Final Submittal

Summary of HPC Coordination (9/12/15)

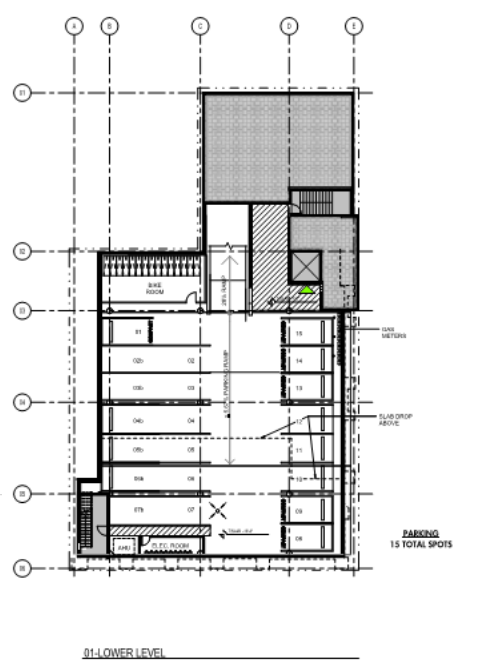
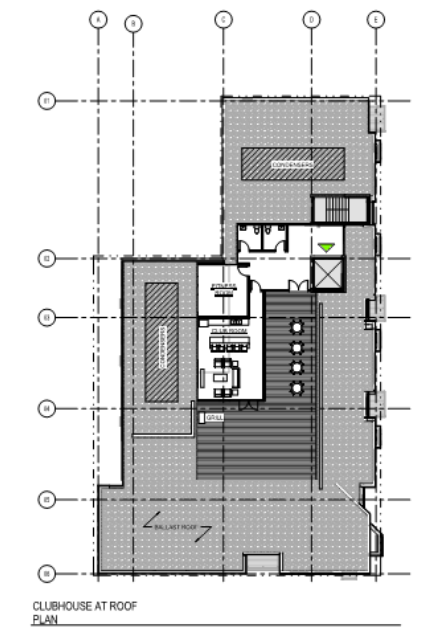
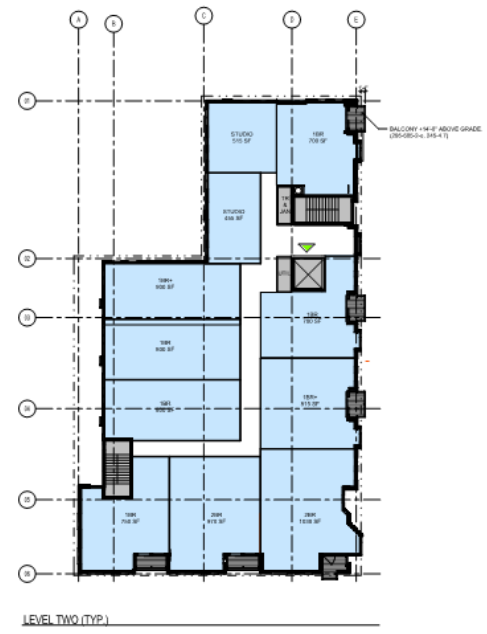
5. Possible reconfiguration of projecting bay at southeast corner facing Humboldt Avenue.

EA Response: The corner has been modified. The Eastern, masonry face of this bay, was shifted East. As such the masonry profile got more slender and the metal bay projection was reduced from 3'-6" to 1'-6". The new 1'-6" projection is less eccentric and matches the other bay projections along Humboldt.
